**CITY OF ST. HELENS PLANNING DEPARTMENT
STAFF REPORT**

Appeal **AP.1.23** of Partition, **PT.1.24**, and Lot Line Adjustment, **LLA.1.24**

ZONING: General Residential, R5 and Mixed Use, MU
LOCATION: 80 S. 21st Street
PROPOSAL: Lot line adjustment and 3 parcel partition of the larger adjusted lot

PRELIMINARY UTILITY PLAN
 SCALE: 1" = 10'

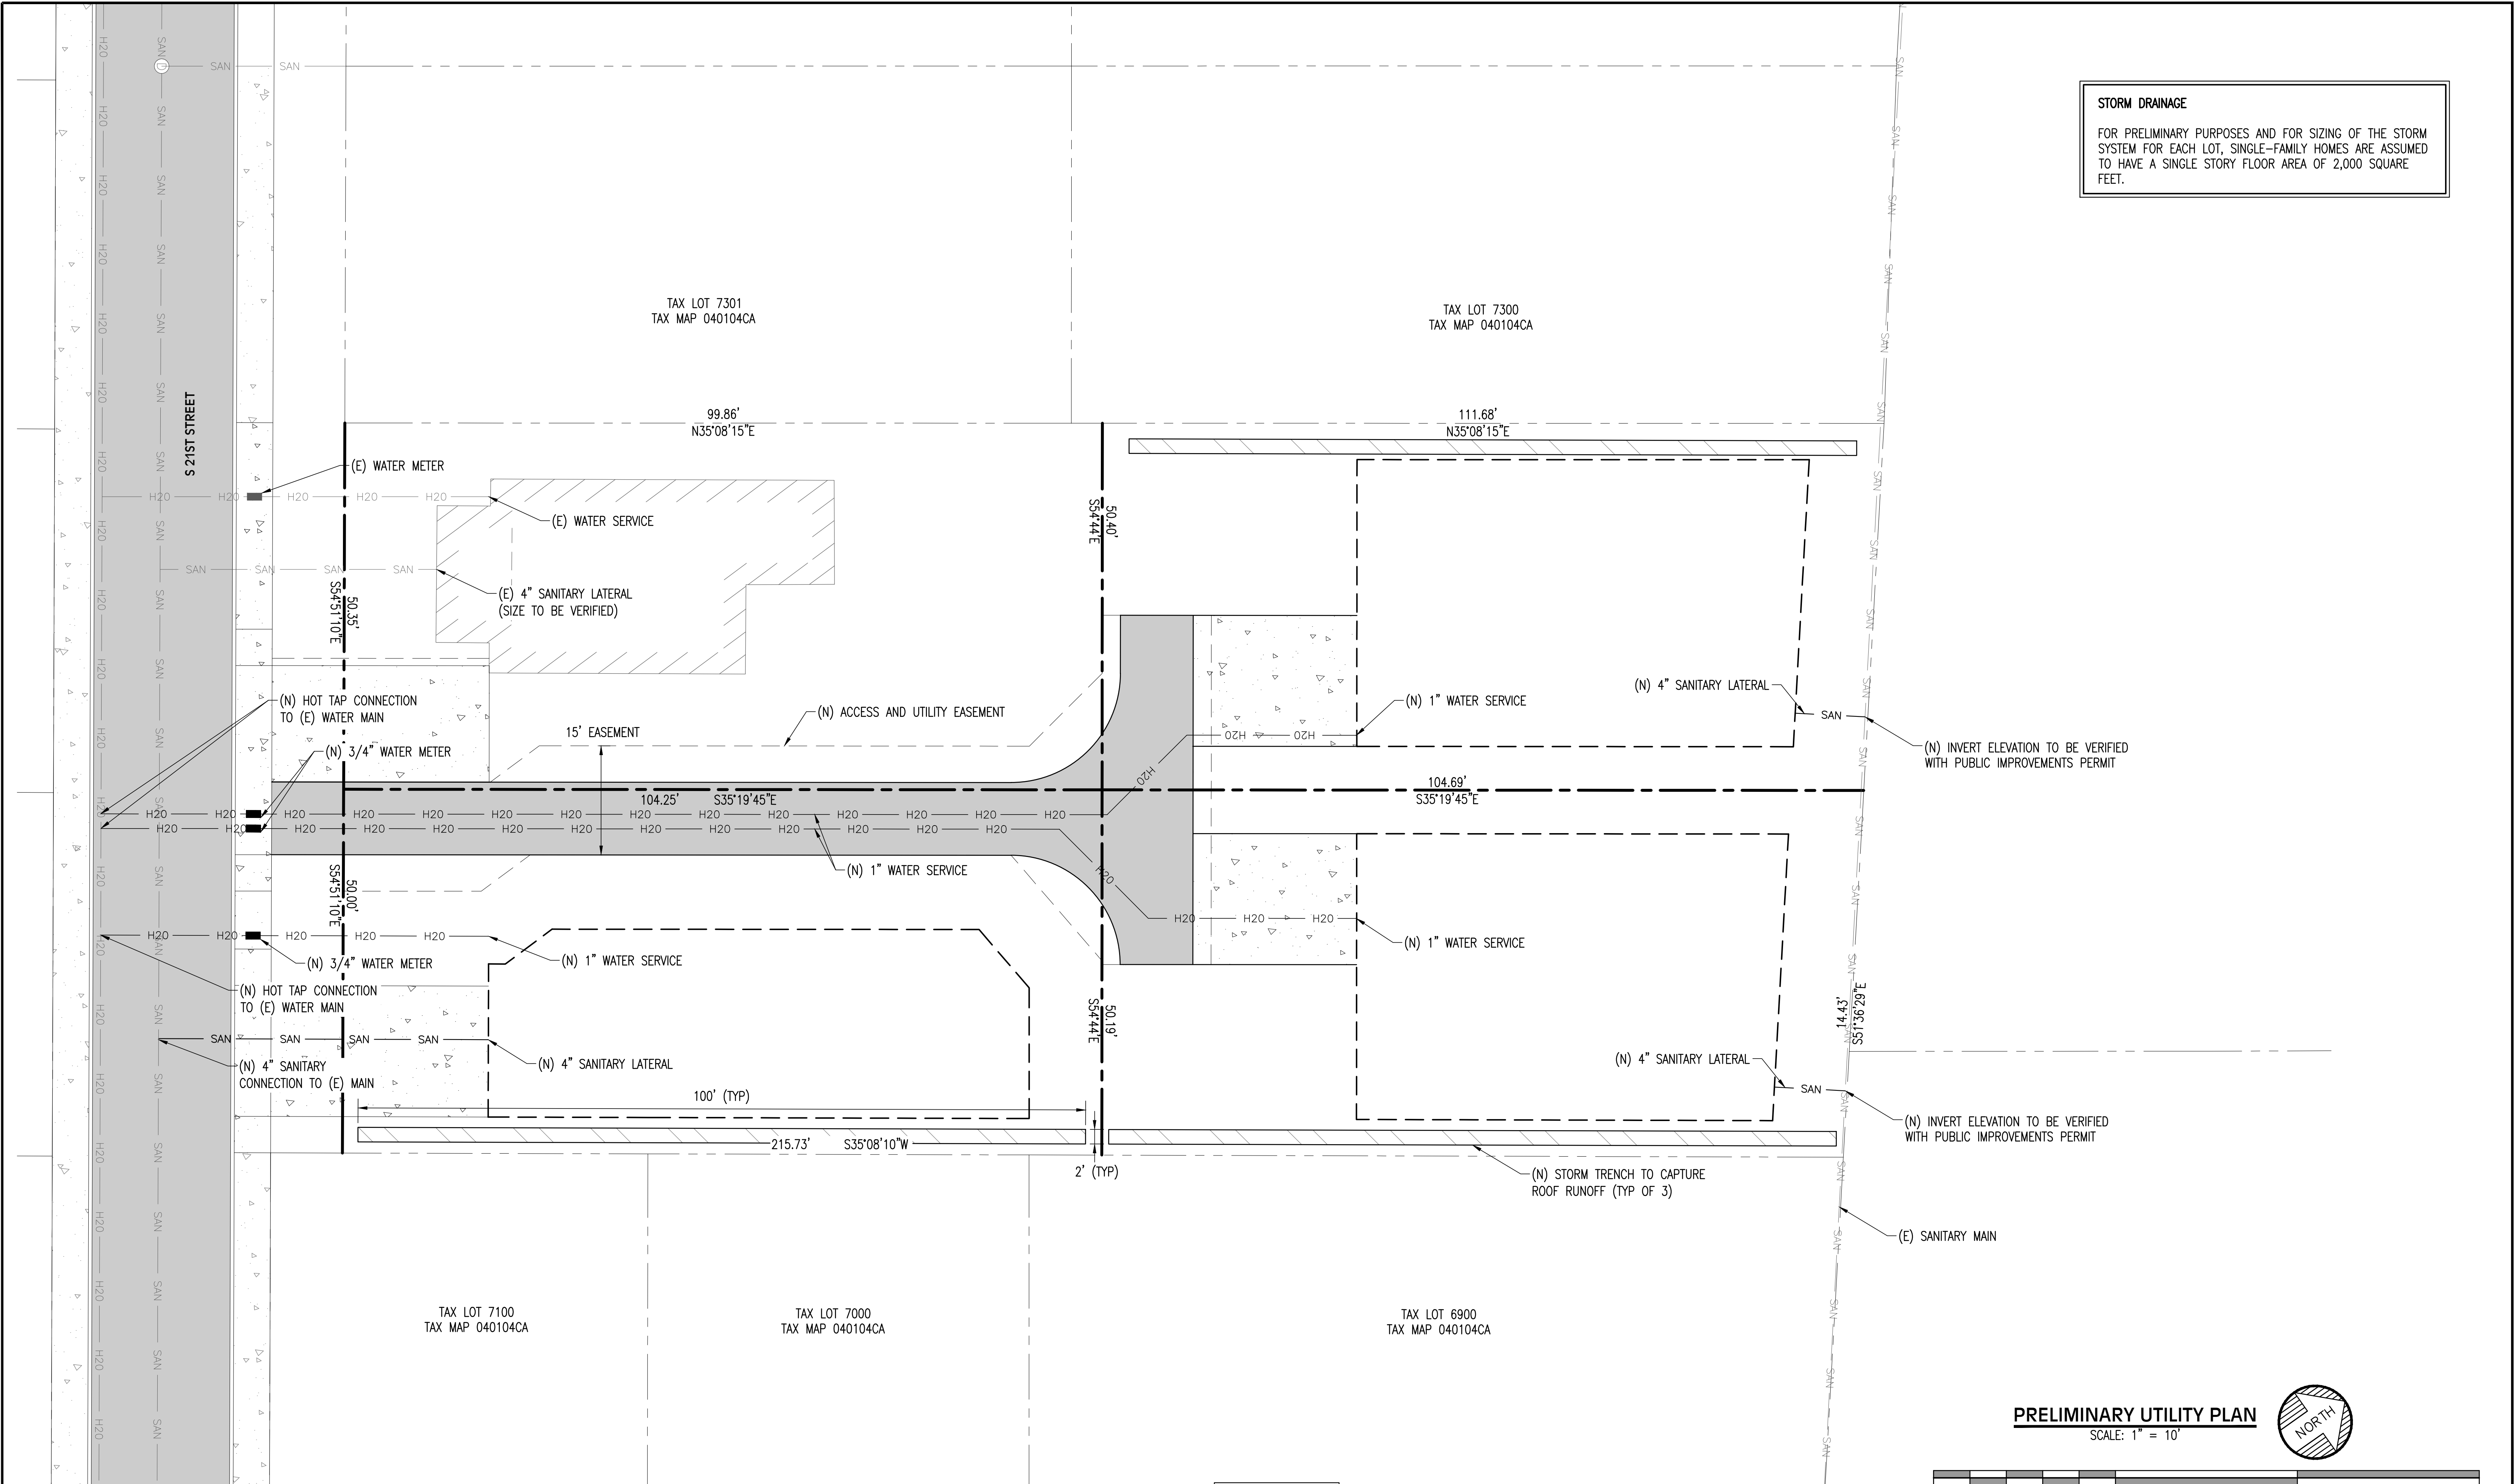
City Engineering comments. See attached email from the city’s Engineering Manager. Basically, this adds more storm water compliance detail. There was already a condition pertain to storm water and this will add to that.

- e. Storm drainage report shall be submitted for city review. Storm water strategy needs to include all anticipated impervious surfaces and be approved by city engineering. **All stormwater shall be detained on the subject property so the post-development rates leaving the site does not exceed the pre-development rates; otherwise, a new storm drain will be required on S. 21st Street connecting to the existing storm main on Crouse Way, with all site storm connected to this new storm system.** Timing of storm water improvements shall be included: required for the partition (before final plat) or when lots are developed (before occupancy), as approved by the city. **If a new storm is required on S. 21st Street, it shall be completed before final plat.**

TREE PRESERVATION AND REMOVAL PLAN
SCALE: 1" = 10'

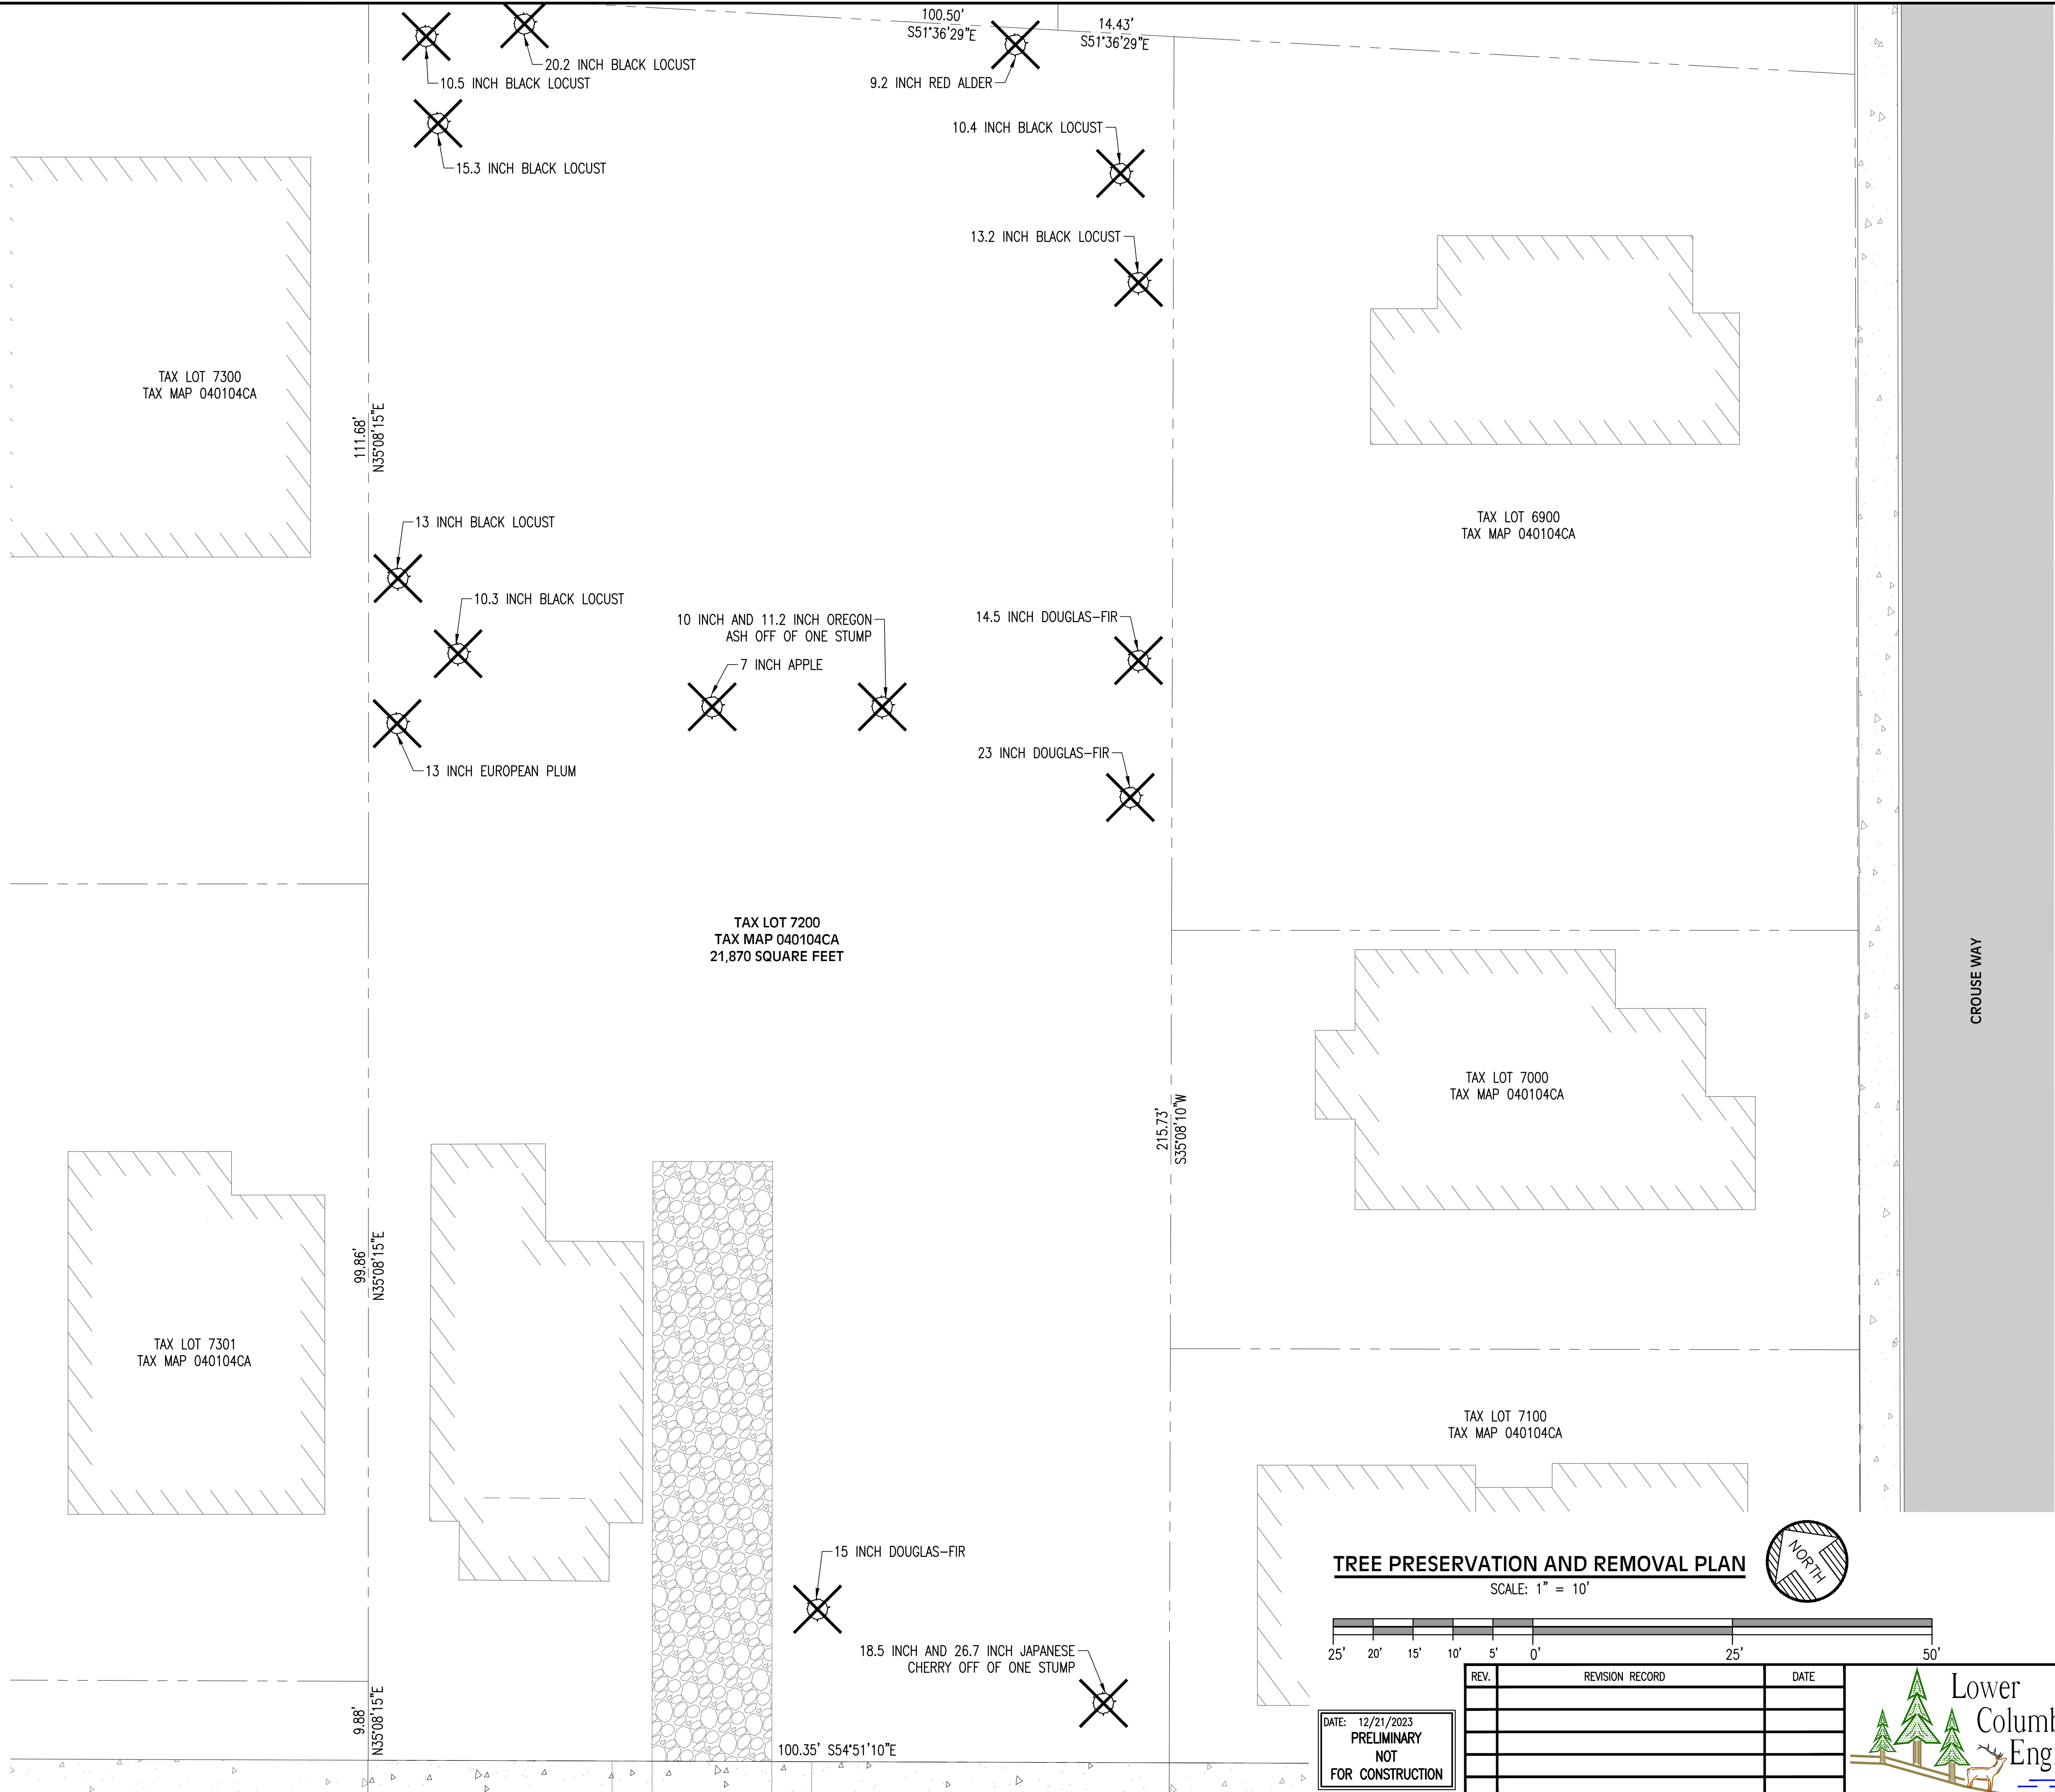
Tree issue. Per SHMC 17.132.025 a tree plan is required for protection, removal and potential replacement of trees. It is required for “any lot, parcel or combination of lots or parcels” involved in the proposal. The particular tree of concern has its trunk on the appellant’s property, with a significant portion of the root system within the subject property. So it is technically on the subject property, just not entirely.

If the roots were severed at the property line, it is assumed more than 50% of the root system would remain, but this still could be an action that results in physiological viability.

Condition 2.c.iii of the original decision requires a protection program by a certified arborist specifically for this tree. **A question for this matter is can we require any more than this or otherwise result in a different decision than the original?**

- iii. **A protection program defining how the large Douglas fir on the adjacent property addressed as 255 Crouse Way close to the property line will be protected during and after development of the affected parcel.**
